# IAR Supplementary Information

Client: Genex Power Limited

Job No.: 60544566

This supplementary information has been prepared in response to comments on the final IAR received from DES on 29 January 2019 (refer to Appendix A of this Supplementary information). It also sets out the results of additional surface water sampling undertaken in February 2019, the scope of which was discussed and agreed with DES. This report should be read in conjunction with the final IAR. Capitalised and defined terms in this report have the same meaning as in the final IAR.

Figure 6 Construction Phase Post-Release Flush Ratios – Annual Results

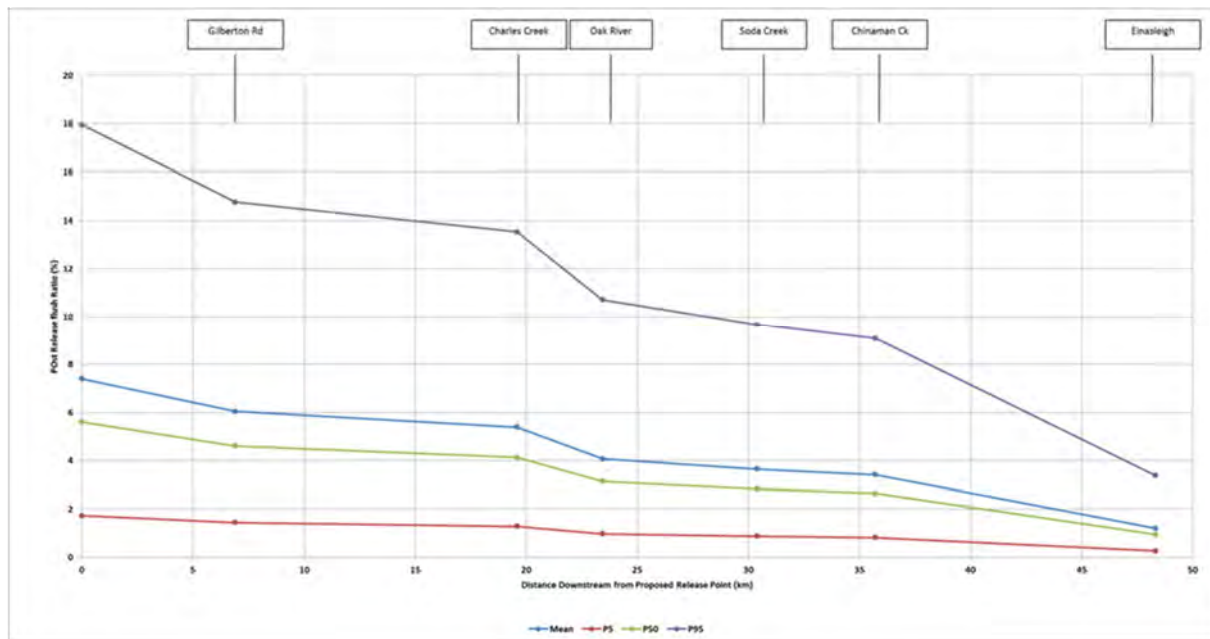
There is a potential risk of algal blooms within the mixing zone and the semi-permanent pools downstream. With the concentration of total nitrogen in the release water 47 times, nitrate 8 times and total phosphorus 2.5 times the WQO. Efficacy of proposed flushing (i.e. cease release at <400ML/d) in downstream water bodies (i.e. Copperfield Gorge) is inadequately discussed.

Detail regarding post-release flushes is presented in Section 6.3.1 (for operational phase releases) and Section 7.4.2 (for temporary construction releases) of the IAR. The efficacy of flushing with regards to the potential for algal blooms is discussed in Appendix B of this Supplementary information.

Analysis of post release flushes show that for 95% of releases, the post release flush at the proposed release point is estimated to exceed seven times the release volume during the operational phase and more than five times the release volume during the construction phase (refer to Table 69 and Table 102 of the IAR). As shown in Figure 6, tributary inflows downstream of the proposed release point provide continual additional flow during the post-release flush period resulting in a continual reduction in the flush ratio<sup>1</sup> with increasing distance downstream of the proposed release point. At Einasleigh (located approximately 48 km downstream of the release point), post release flushes are estimated to exceed the release volume by approximately 42 times during operations and 29 times during construction for 95% of releases.

Figure 8 Simulated release flows and zinc concentrations during the first 100 days of the construction phase

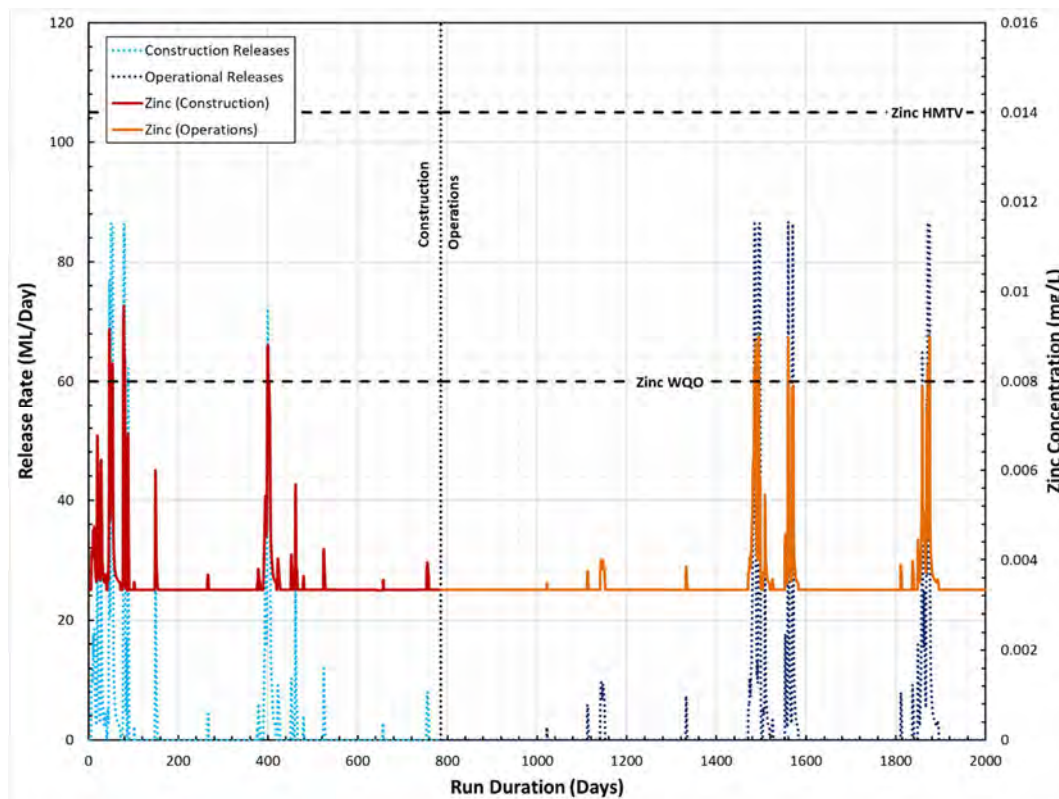
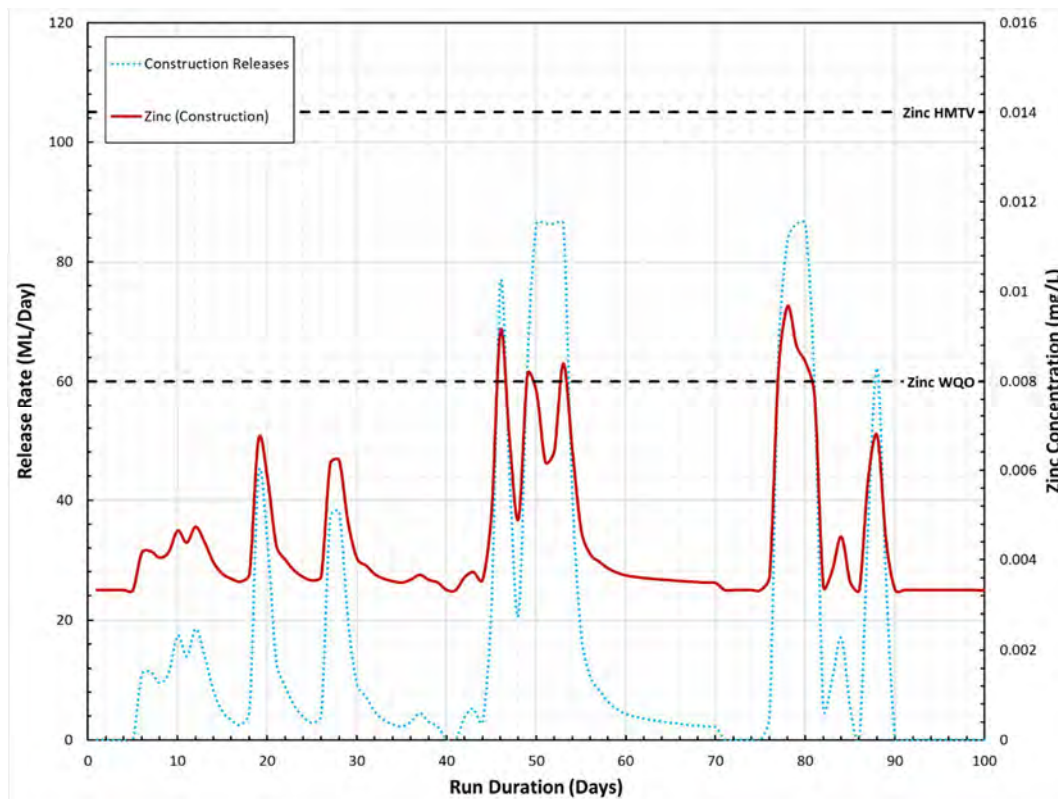
The concentrations represented by the mass balance will only be present whilst the release is occurring. However, the section does not provide examples of how long the system takes to return to < WQOs, how long the water takes to move from Kidston to Einasleigh, etc.

The IAR needs to detail, how long the system takes to return to < WQOs in scenarios where they are being exceeded for large periods downstream, how long the water takes to move from Kidston to Einasleigh (i.e. days/weeks), how long will elevated concentrations be present at that location; and the proportion of days per year where there is 'unimpacted' water present in the system, compared to release impacted days.

An assessment of the system response timing was undertaken using the GoldSim water and mass balance model developed for the Project. It is important to note the following with regards to the assessment:

Figure 8 details simulated releases within the first 100 days of the construction period. Note that the simulations predict zero exceedances of the HMTV for zinc. Downstream zinc WQOs are predicted to be exceeded briefly. Since the load added to the Copperfield River is depended on the release flow, once a release period ends, concentrations are calculated to return to below the WQO within approximately two days and to return to baseline Copperfield River concentrations (0.0025 mg/L) within approximately ten days, which is consistent with the post-release flushing estimated in the IAR.

As above, this is dependent on the load added to the Copperfield River, which is dependent on the release flow rate and the maximum is simulated to be in the order of approximately ten days (Figure 8).
